BROWNS FERRY NUCLEAR PLANT (BFN) - UNITS 1, 2, AND 3 -  
TECHNICAL SPECIFICATIONS (TS) CHANGES TS-431 AND TS-418 -  
EXTENDED POWER UPRATE (EPU) - RESPONSE TO ROUND 6 REQUEST FOR  
ADDITIONAL INFORMATION (TAC NOS. MC3812, MC3743, AND MC3744)

#### TECHNICAL SPECIFICATIONS (TS) CHANGES TS-431 AND TS-418 - EXTENDED POWER UPRATE (EPU) - RESPONSE TO ROUND 6 REQUESTS FOR ADDITIONAL INFORMATION (TAC NOS. MC3812, MC3743, AND MC3744)

#### RESPONSES TO REQUEST FOR ADDITIONAL INFORMATION

Figure ACVB.57/55-1  
Model Schematic

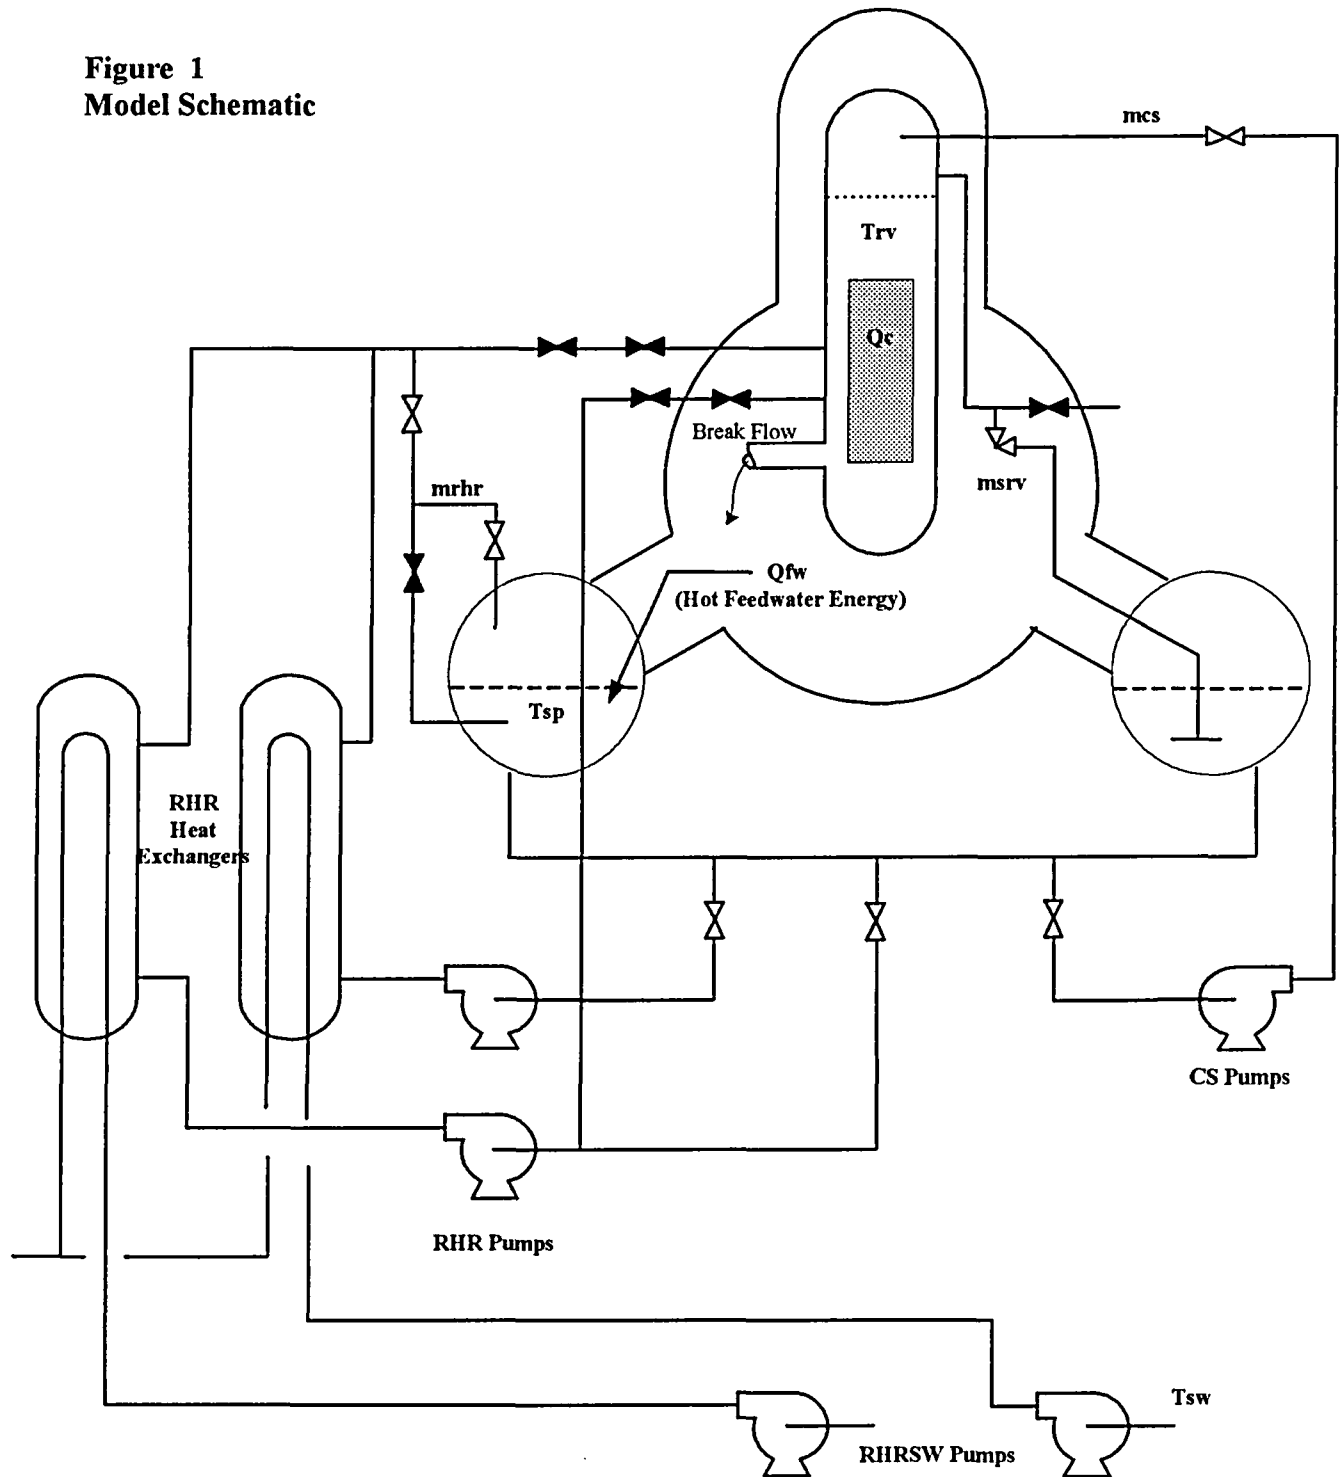
The response to RAI SPSB-A.11 provided Table SPSB-A.11-2, which contains calculations of suppression pool temperature with various assumptions. The cases are identified as either GE or TVA. Describe the analytical methods used for the TVA calculations and the steps taken to ensure a meaningful comparison with SHEX.

The TVA analytical method employed in the sensitivity study cases reported in Table SPSB-A.11-2 uses a simple, one-dimensional model of the suppression pool, the RCS and the RHR system, developed as shown in the attached schematic diagram (Figure ACVB.57/55-1). The mass and energy balance equations for this system were solved for suppression pool temperature. In order to ensure a meaningful comparison with design basis analysis methods, the model was benchmarked against existing GE results obtained with SHEX as shown in Case 1a of Table SBSB-A.11-2. The range of input parameters used to generate additional cases is limited to small changes and basic thermodynamic principles to ensure that the benchmarking remains valid. TVA and GE case results given in Table SPSB-A.11-2 are consistent over the range of parameters used in the sensitivity analysis.
